## PRE-BID ADDENDUM NO. # 2

**PROJECT:** Orange County Community College  
Physical Education Center HVAC Roof Top Unit #7-12 Replacement  
OCCC Project No. ITB-OCCC-2023-19  
F.E. Project No. 22-059

**DATE:** November 3, 2022

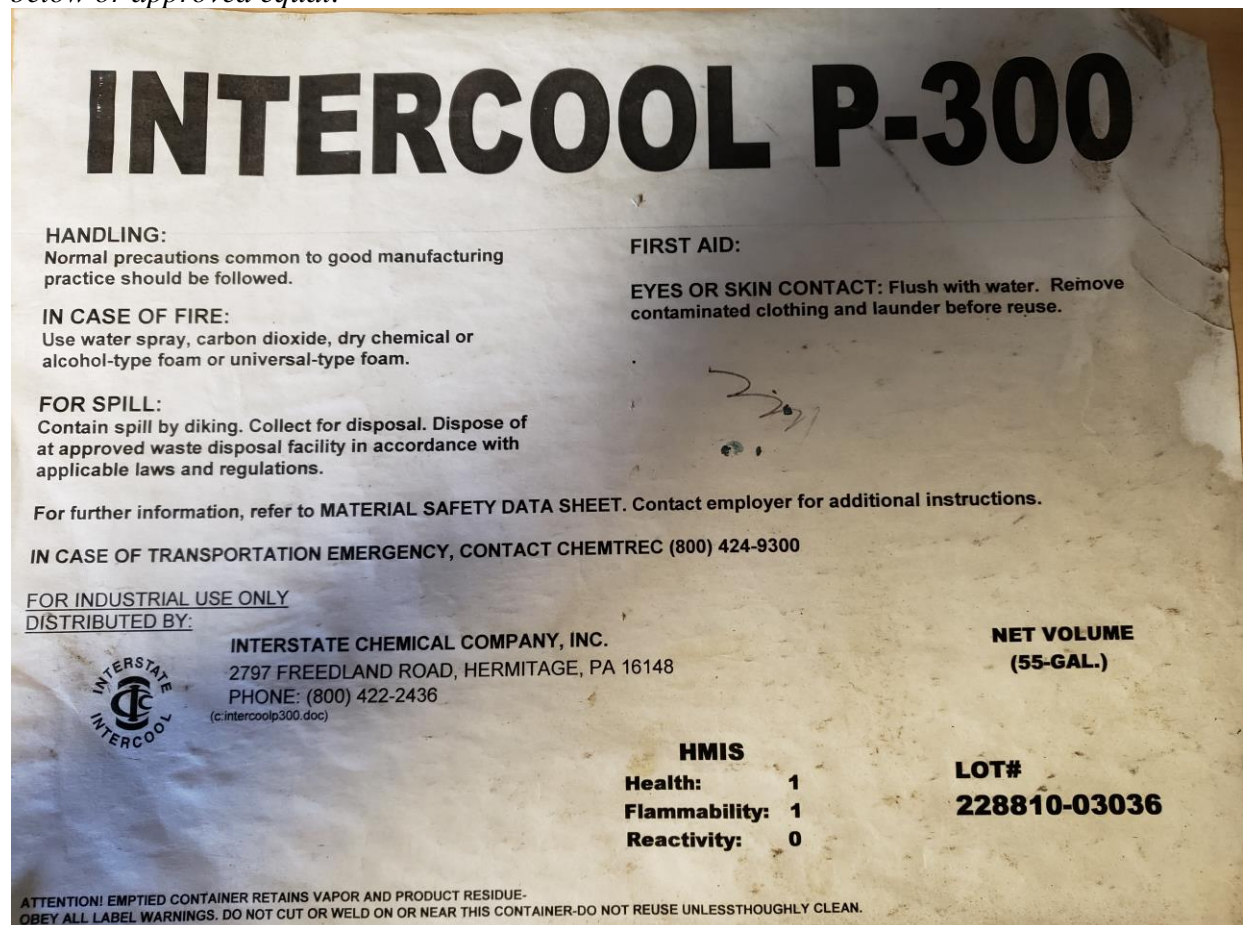
4. What is the percentage of glycol required for this system?

*FE Response: Pre-demolition the contractor shall test the existing glycol solution percentage in the system for use during the refilling process. A pre-demo test report shall be provided to the engineer and school for record. For bidding purposes provide 40% glycol solution utilizing the material shown below or approved equal.*
